Point-by-point reply to review by Dr. Chris Sioris

By Xi Xi on June 23, 2015

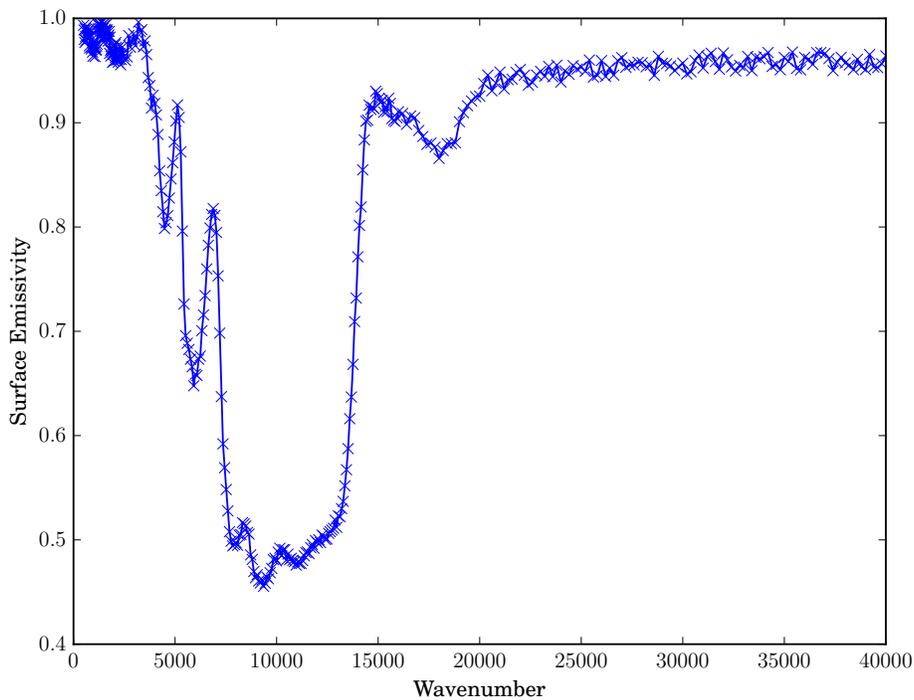
Comment: *There is no precision requirement on XH_2O but precise XH_2O is required for objective 3. There is no accuracy requirement for any gases, but maybe there should be. The retrieval bias for xCH_4 for all-sky conditions is larger than the precision requirement. Is that a concern?*

Reply: Up to now, there are no systematic studies that quantify the precision requirement on XH_2O , so there is not benchmark to adhere to. Because of this, it is hard to judge if the retrieval precision for XH_2O is precise enough or not. The statement about “precise XH_2O ” is indeed ambiguous and we will rephrase it in the revised manuscript. As there are no studies that quantify accuracy requirements, we did not focus on retrieval accuracy.

It is true that the retrieval bias for XCH_4 for all-sky conditions is larger than the precision requirement. However, in real retrievals, the retrieval biases will be corrected through validation with ground-based measurements and the implementation of correction factors. Therefore, the retrieval biases are not comparable to the precision requirement and this does not need to be a concern.

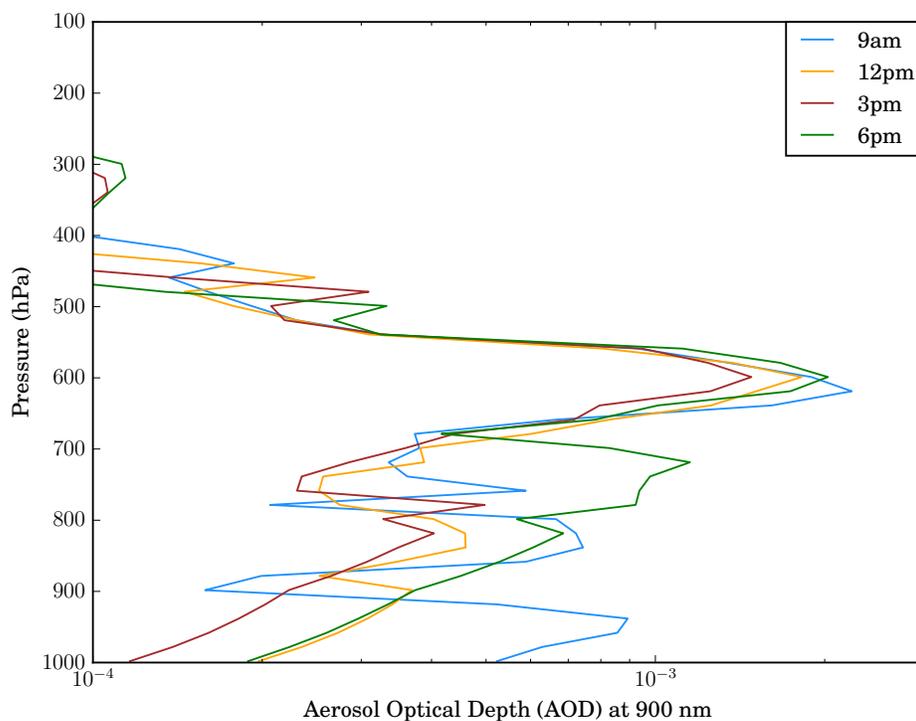
Comment: *The aerosol loading for the all-sky cases are not clear. An input OD of 0.2 is mentioned in section 3.3 but the authors don't disclose the input OD for retrieval results reported in section 3.2. Rather than be quantitative, the authors state "small amount" on P5817L9 and "less than ~0.30" on p5824L23 and "small amount" again on P5826L20. This is not acceptable. Furthermore, "amount" is a vague term.*

Reply: We would like to clarify that we did not intend to "cover up" the input OD for retrieval results. The input OD was not disclosed because this section was meant for a brief exploration on the influence of aerosols and clouds and the input OD is not new science to be presented. The figure on the next page shows the vertical profile of the aerosol optical depth at location 1. As this figure offers little new scientific insight to the reader, it was omitted from the manuscript. Again, this omission was not meant to cover up any undesirable details.

On P5817L9, the phrase "small amount" was used as a brief mentioning of the addition of aerosols and clouds to the model atmosphere. As section 2.2.1 is focusing on the forward model, we did not see the need to give the details of aerosols and clouds because they might deviate from the focus of this section. On P5824L23, "less than ~0.3" optical depth was the definition of the "small amount of aerosols and clouds" which pass through the pre-retrieval filtering. Because this is the amount of aerosols and clouds that a retrieval algorithm needs to deal with, we decided to study the total scattering OD that ranges from 0.0 to 0.20. On P5826L20, the "small amount of aerosol and cloud contamination" is referring to total scattering optical depth less than ~0.30. It is agreed that "amount" is a vague term. A more quantitative term is total scattering OD, as used

in this study. The phrase “small amount” was meant as a reference to the total scattering OD below ~ 0.30 . We will add one sentence to the revised manuscript to clarify this point.

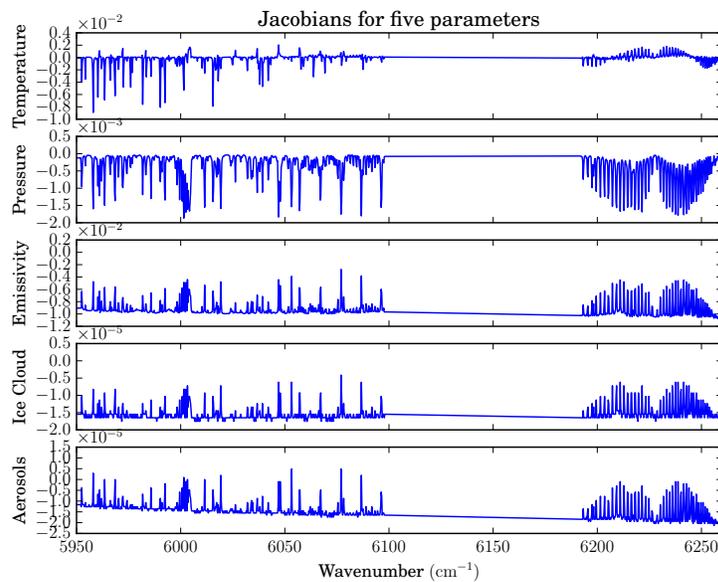
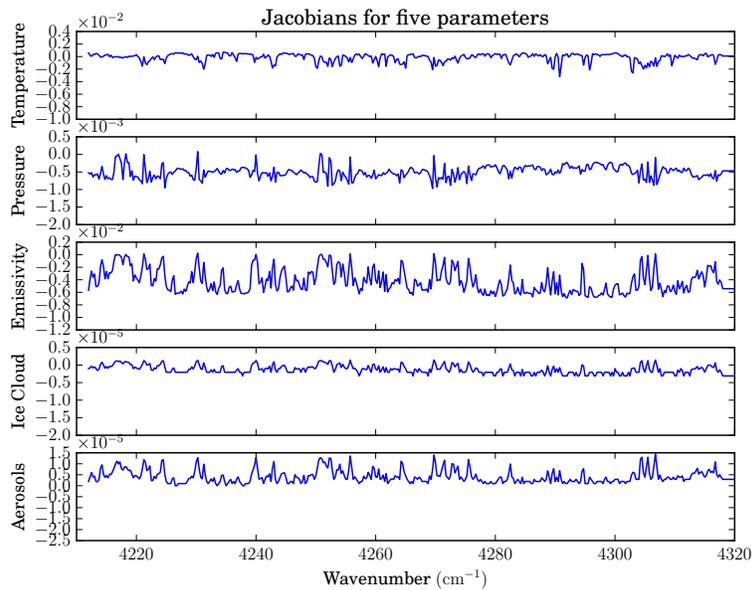
Comment: I would like to see the Jacobians for five of these other parameters: temperature, pressure, surface emissivity, clouds, and aerosols. I would like to see the correlation coefficient for aerosols and cloud Jacobians. Also, what is the correlation coefficient between the Jacobian spectrum for pressure and each of the following Jacobian spectra: CH_4 , CO_2 and H_2O .

Reply: The figures below show the Jacobians for the five parameters. The correlation coefficients, r , are as follows: r (aerosol jacobian and cloud jacobian) = 0.91; r (pressure, CH_4) = 0.45; r (pressure, CO_2) = 0.53; r (pressure, H_2O) = 0.43.

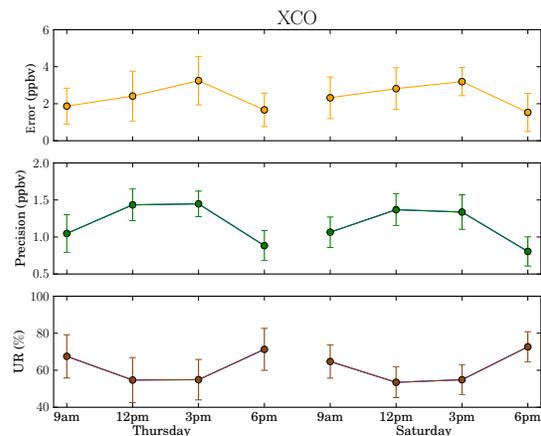
Comment: The authors could have explored the ability to detect the weekend effect in CO₂ or CO. Otherwise, what was the point of using two different days of the week?

Reply: We have analyzed the retrieval results over two different days of the week. The figure on the right shows the results for XCO over a Thursday and a Saturday. It shows that, regardless of the amount of CO during a weekday or a weekend day, the patterns for retrieval error and precision are similar. Therefore, we aggregated the results from different days to one single figure in Figure 7, instead of having one figure for each gas species. Figure 7 in the current manuscript is in a more condensed form and it still conveys the key scientific message.
